ATTACHMENT 1

Draft SER Open Item No. 172 (Sections 2.5.4.1.2 and 2.5.4.5) - Longitudinal Sections and Parameters of Category I Buried Pipelines:

FIGURE 2.5.4-62

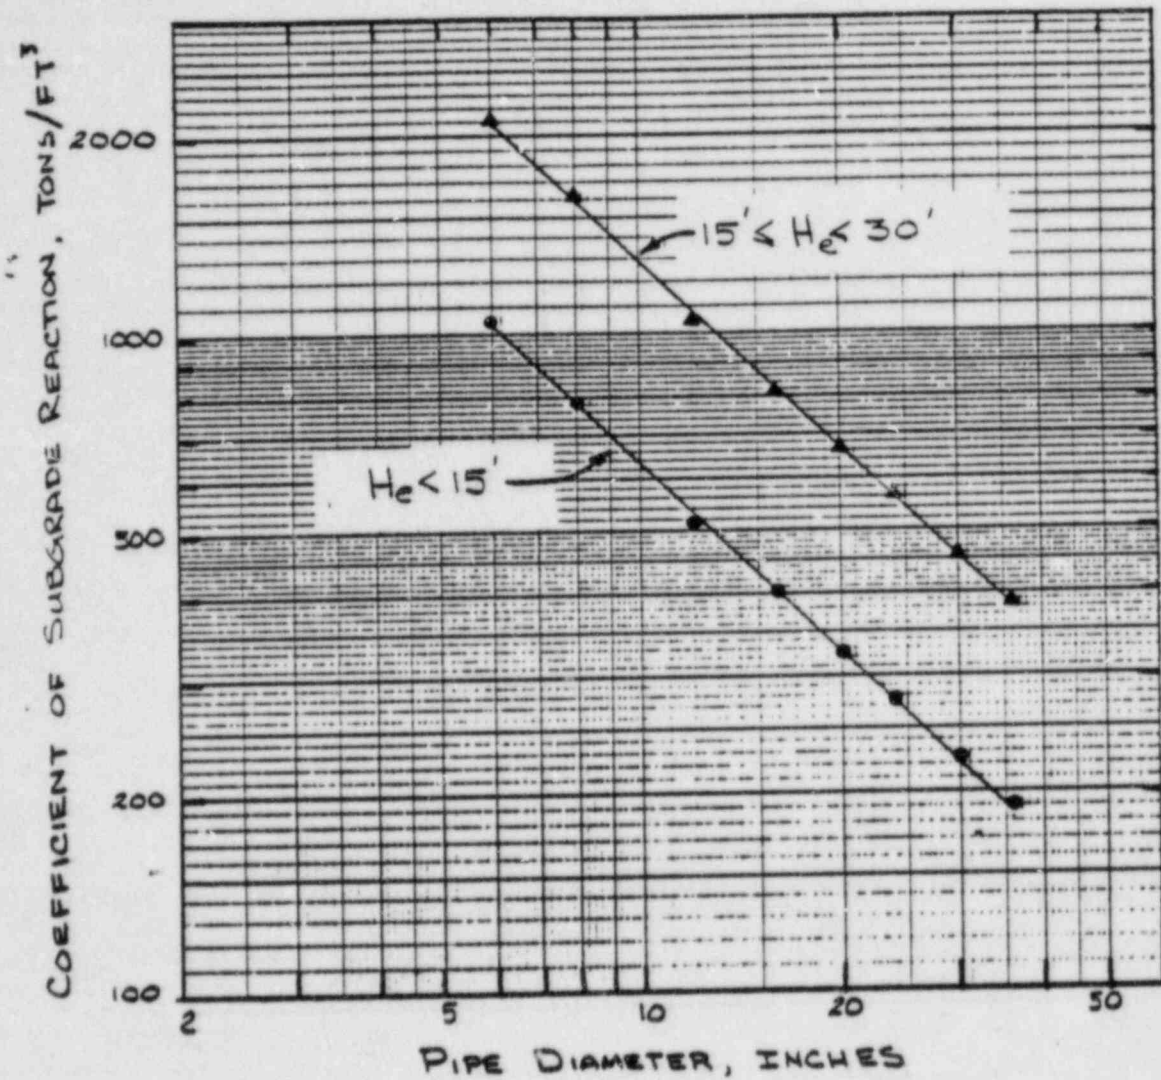
The applicant has agreed to furnish longitudinal sections of all Category I pipelines (1) from the Valve Pit No. 1 to the main plant structures, and (2) from the main plant area to the Emergency Outfall structure. These sections should show the soil profile and the static and dynamic soil properties used in the pipe stress analysis, such as the subgrade modulus, shear wave velocity, shear modulus, etc.

1. Furnish longitudinal sections of Category I pipelines and ducts not already provided showing therein the soil profile and the elevations at which the pipes are laid. Locations of manholes and their foundation configuration should also be shown in these longitudinal sections.
2. Provide the actual values of the geotechnical parameters such as subgrade modulus, shear wave velocity and soil modulus, etc. used in the static and dynamic analysis of buried pipes.

The vertical coefficient of subgrade reaction for buried pipe was computed according to the following equation (Vesic 1961, 1961a):

An average, low strain value of shear modulus, G , was estimated using equation 2.5.4-5 for two ranges of pipe embedment depth, H_e :

Using these values of shear modulus, Young's modulus, with a reduction to account for strain, was estimated as:

Vertical coefficient of subgrade reaction is shown in Figure 2.5.4-62 as a function of depth of embedment and pipe diameter.
